SUBJECT: Administrative Approval for Petition No. 2008-031 Mountain Island Promenade, LLC

Attached is the revised site plan for the petition above. This request allows the modification of the proposed site plan as listed below. Since these changes do not alter the intent of the development and meets the requirements of the Charlotte Zoning Ordinance Section 6.207 Alterations to Approval, minor changes, I am administratively approving this plan. Please use these plans when evaluating requests for building permits and certificates of occupancy.

PETITION #:2008-031
REZONING SCHEMATIC SITE PLAN C

Title: **SITE PLAN FOR PHASE 1**

CO.0

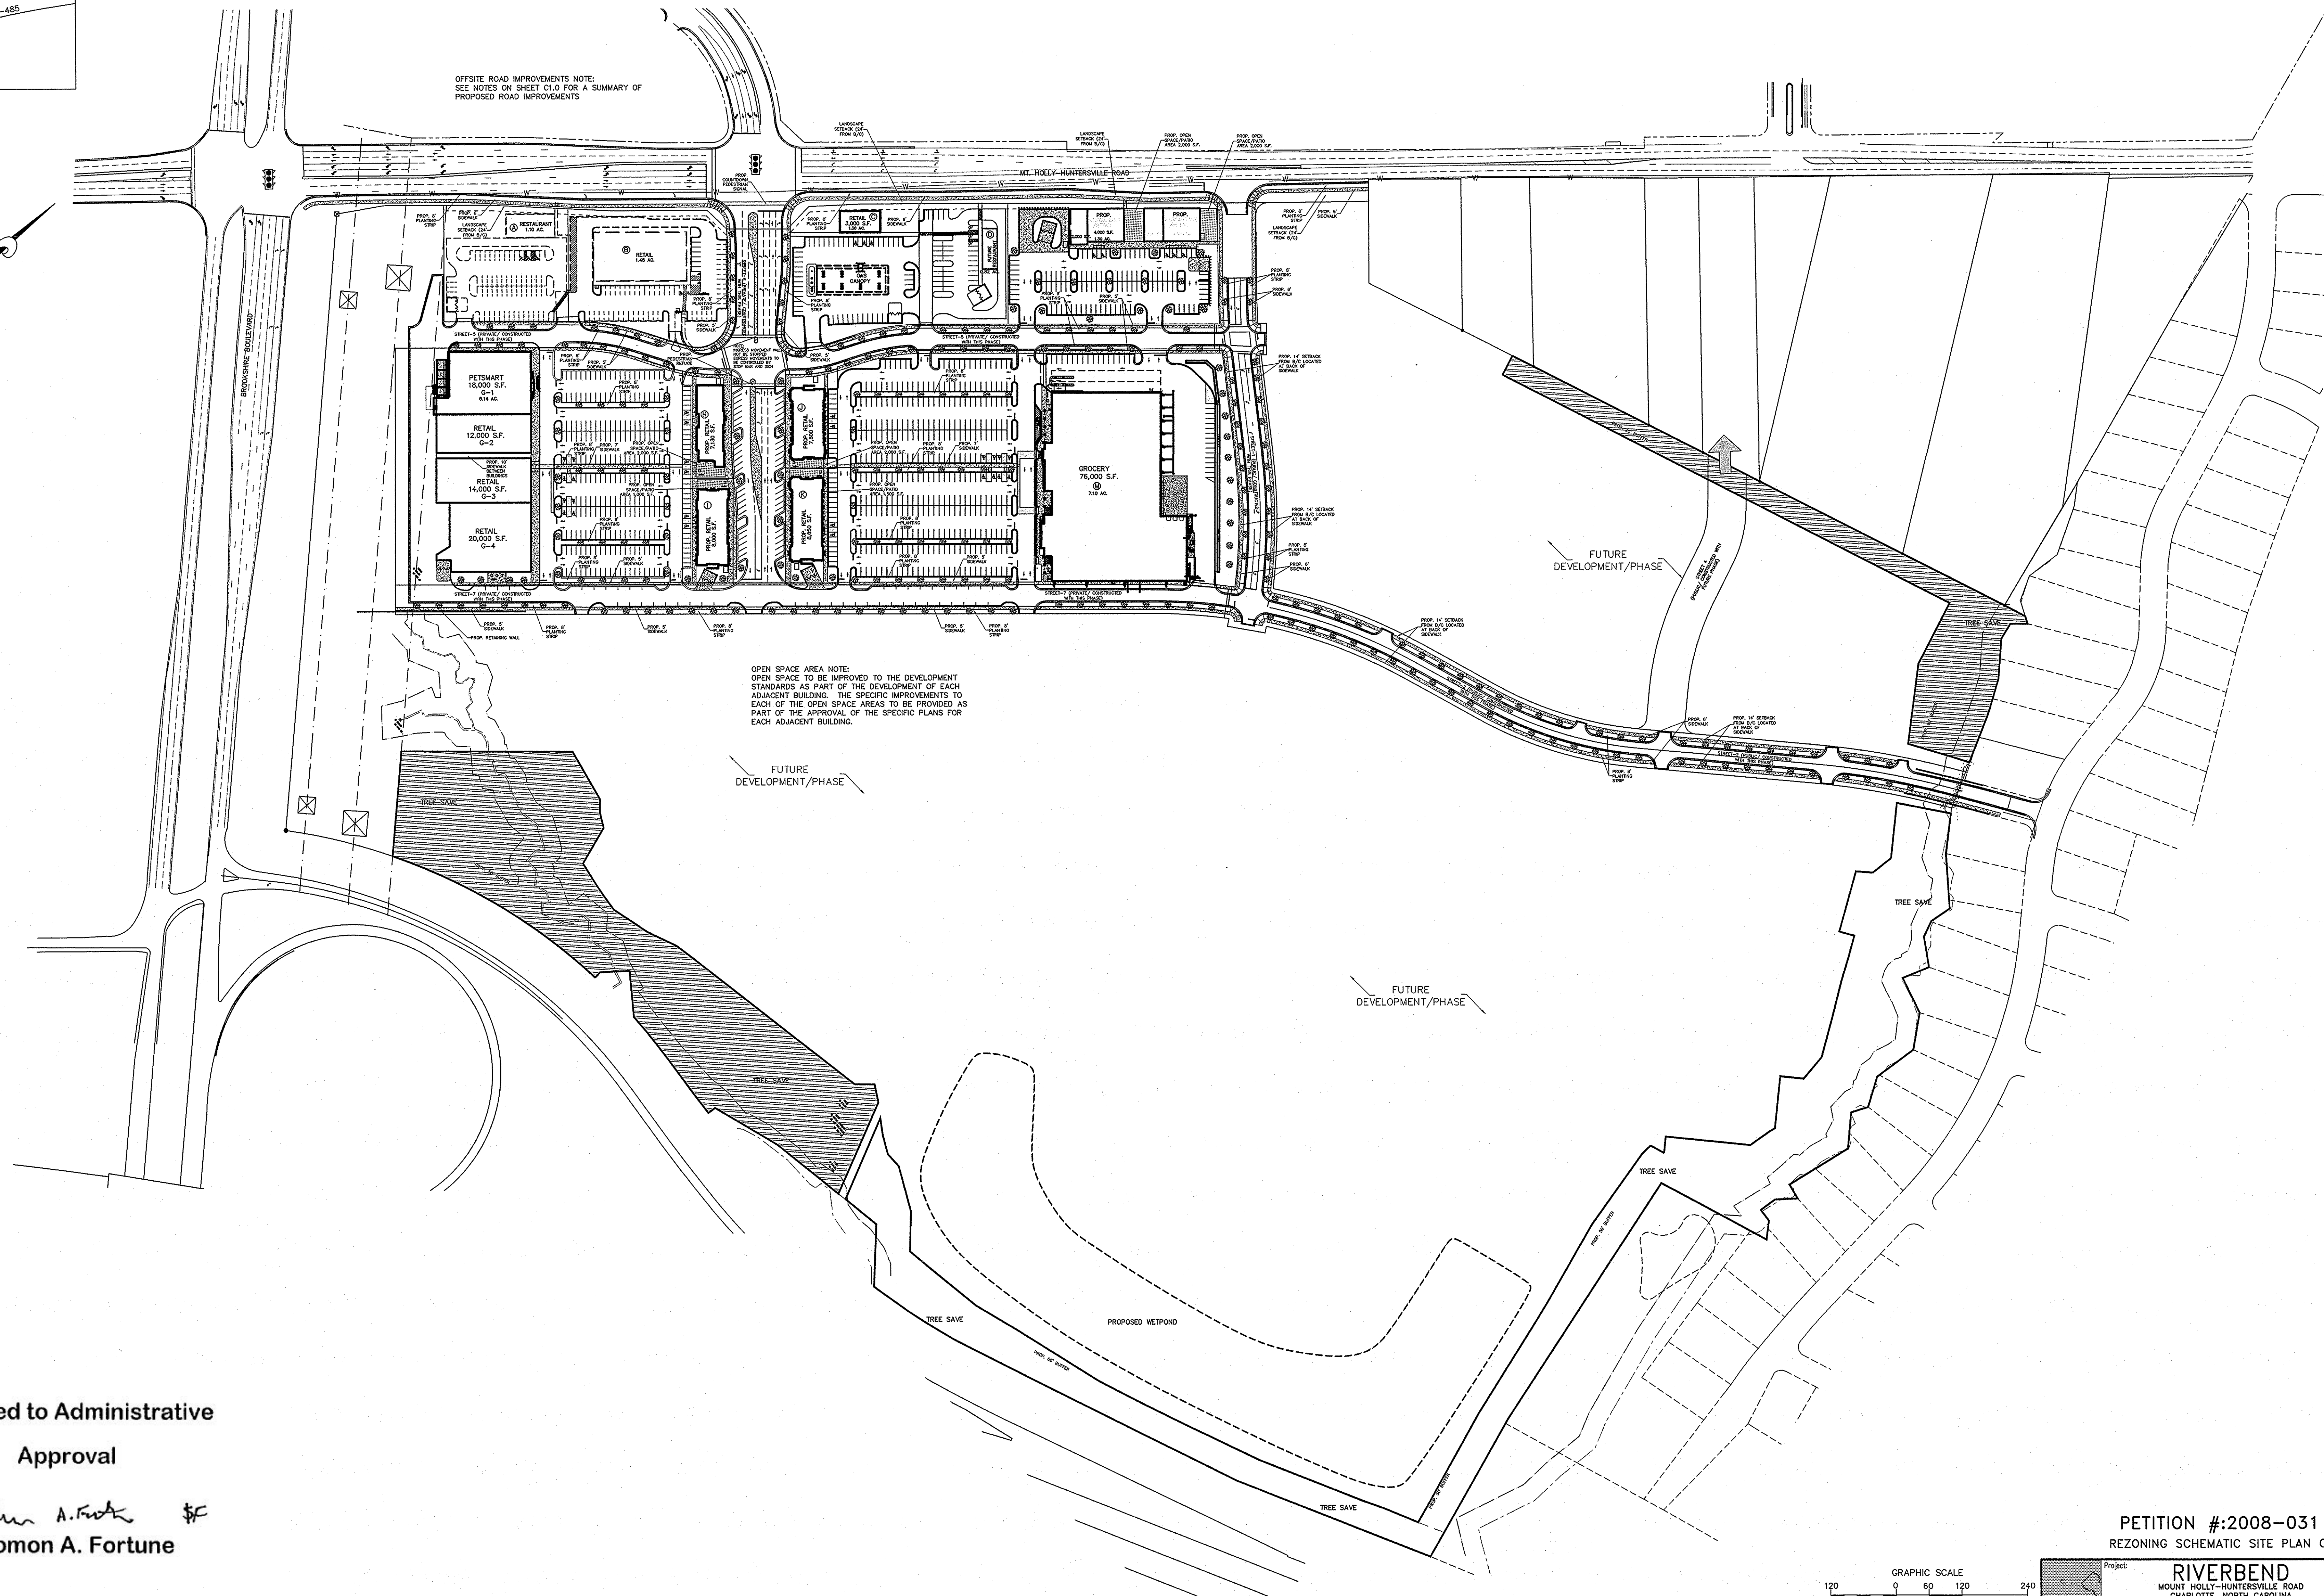
- General layout for proposed retail buildings.
- Note modification: Elevation and review will happen prior to commercial building standards review.
- Master site development record
- Open space and green areas are tied to certain buildings being developed.
- Screening wall along proposed internal public street
